PIC16(L)F1826/1827 Family Silicon Errata and Data Sheet Clarification

The PIC16(L)F1826/1827 family devices that you have received conform functionally to the current Device Data Sheet (DS41391C), except for the anomalies described in this document.

The following typographic corrections and clarifications are to be noted for the latest version of the device data sheet (DS41391C):

FIGURE 1: INSTRUCTION CYCLE DELAY CALCULATION EXAMPLE

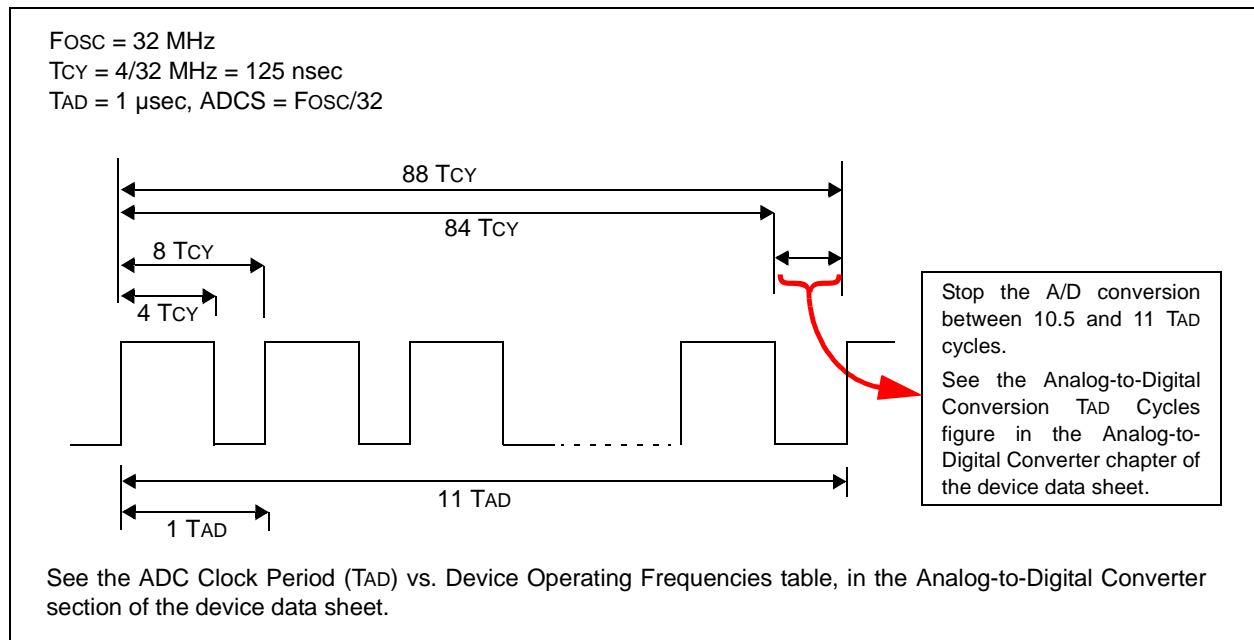
An ADC conversion may not complete under these conditions:

1. When FOSC is greater than 8 MHz and it is the clock source used for the ADC converter.
2. The ADC is operating from its dedicated internal FRC oscillator and the device is not in Sleep mode (any FOSC frequency).

When this occurs, the ADC Interrupt Flag (ADIF) does not get set, the GO/DONE bit does not get cleared, and the conversion result does not get loaded into the ADRESH and ADRESL result registers.

Method 3: This method is provided if the application cannot use Sleep mode and requires continuous operation at frequencies above 8 MHz. This method requires early termination of an ADC conversion. Provide a fixed time delay in software to stop the A-to-D conversion manually, after all 10 bits are converted, but before the conversion would complete automatically. The conversion is stopped by clearing the GO/DONE bit in software. The GO/DONE bit must be cleared during the last ½ TAD cycle, before the conversion would have completed automatically. Refer to Figure 1 for details.

In Figure 1, 88 instruction cycles (TCY) will be required to complete the full conversion. Each TAD cycle consists of 8 TCY periods. A fixed delay is provided to stop the A/D conversion after 86 instruction cycles and terminate the conversion at the correct time as shown in the figure above.

Note: The exact delay time will depend on the TAD divisor (ADCS) selection. The Tcy counts shown in the timing diagram above apply to this example only. Refer to [Table 3](#) for the required delay counts for other configurations.
